Subject: DIR1701 and DIR1703 UNLOCK problem

Summary of Problem and Proposed Solution

Fig. 1 LRCKO duty cycle and preamble position change at CKTRNS = HIGH

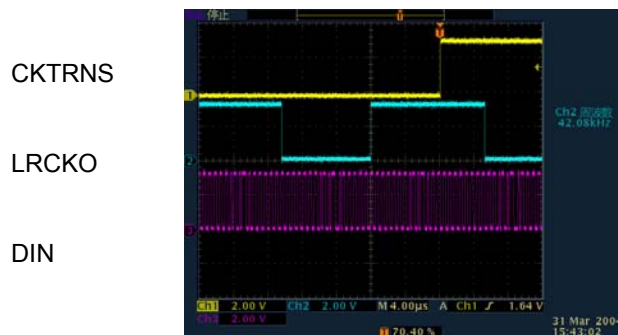
When the sampling frequency changes, the DIR1701/DIR1703 unlock and fail to re-lock at the new sampling rate. In general, during normal operation an S/PDIF receiver outputs an UNLOCK flag when the sampling frequency of the S/PDIF data changes. After the receiver has locked to the new sampling frequency, the device outputs a LOCK flag. The DIR1701/DIR1703 is unable to correctly re-lock onto the new sampling frequency. Specifically, after the sampling frequency changes the LRCKO output becomes unstable and can create noise that will be passed through an audio DSP or audio DAC.

To lock onto a new sampling frequency, the DIR1701/DIR1703 requires an external reset signal every time the S/PDIF audio sampling frequency changes. A microcontroller or DSP would typically be required to provide this reset signal in a system.
